Service Bulletin

Bulletin No.: 23-NA-073

Subject: Evaporative DTCs P0442, P0446, P0455 or P0449, Caused by Dust Intrusion into the Evaporative Canister and Canister Vent Solenoid

6327015

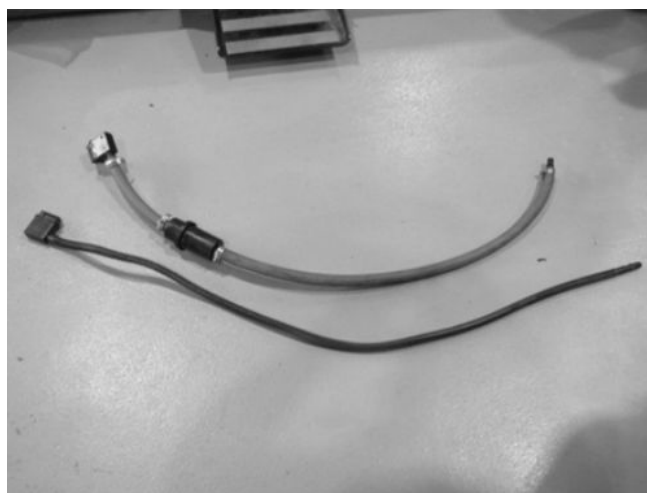
A filter may be installed between the EVAP canister and air inlet, to correct this Condition. An example of the original, and the retro-fit, evaporative emission canister vent hose are shown in the graphic above.

Note: The retro-fit to add the filter is described in the Service Procedure below. For the retro-fit, the filter assembly P/N (with the 3 parts shown above) will need to be utilized along with a 3/4" to 5/8" hose connector that can be obtained for a local parts store. If a vehicle has already undergone the retro-fit and the vehicle returns after a period of time with the Condition reappearing, the filter assembly can be changed.

Note: The filter is meant to be a maintenance item that should be checked periodically to prevent the issue from reoccurring and the DTC from setting.

6325322

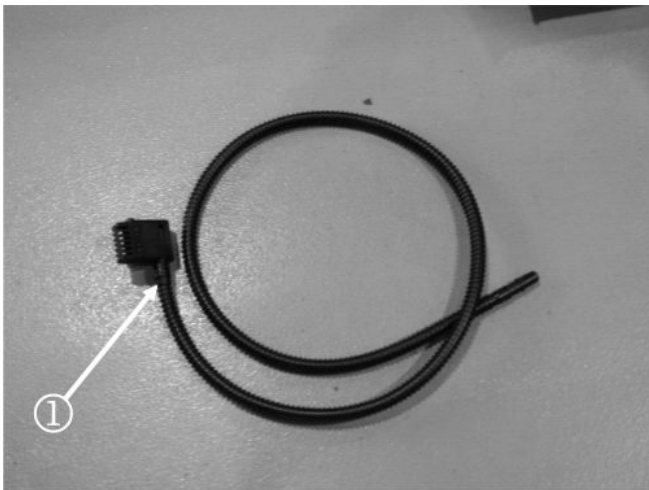
2. Remove the evaporative emission canister vent hose (3). Refer to the appropriate *Evaporative Emission Canister Vent Hose Replacement (Filler Pipe to Pipe)*, in SI.

3. Cut the vent hose at the end of barbed fitting on the pre filter (1).

6325324

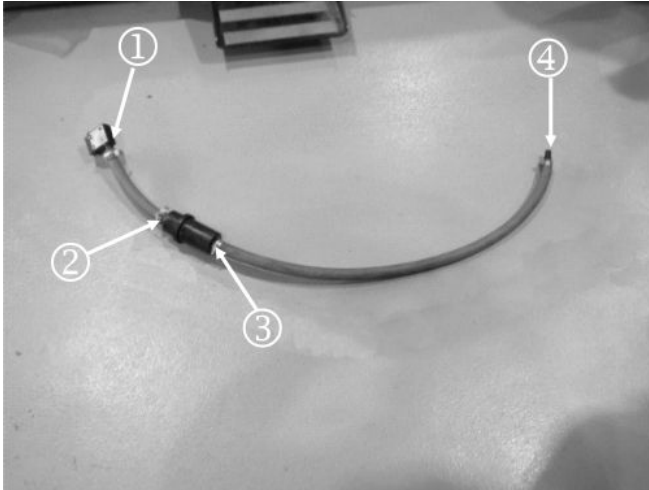
4. Cut a 12 inch (30.5 cm) length of 3/4 in. diameter heater core hose.

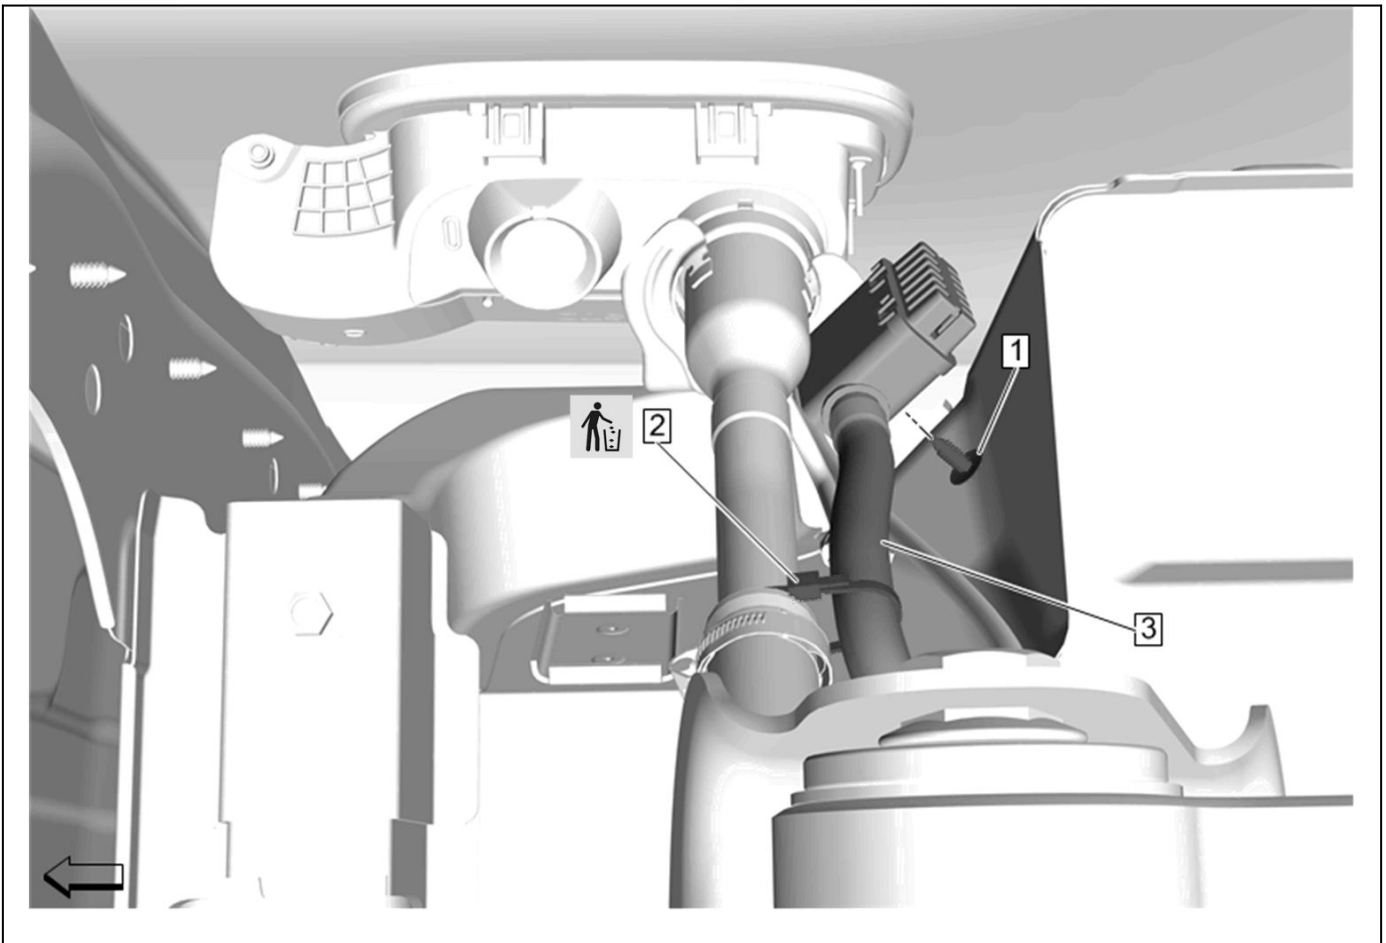
6. Secure the 12 inch (30.5 cm) length heater core hose to the fitting on the pre filter (1), using a hose clamp.
7. Secure the in-line filter (2) to the other end of 12" (30.5 cm) length hose, using a hose clamp.
8. Secure the longer heater core hose to the fitting at bottom of in-line filter (3), using a hose clamp.
9. Insert 5/8" male to male fitting (4) into heater core hose on CVS side, using a hose clamp to secure.
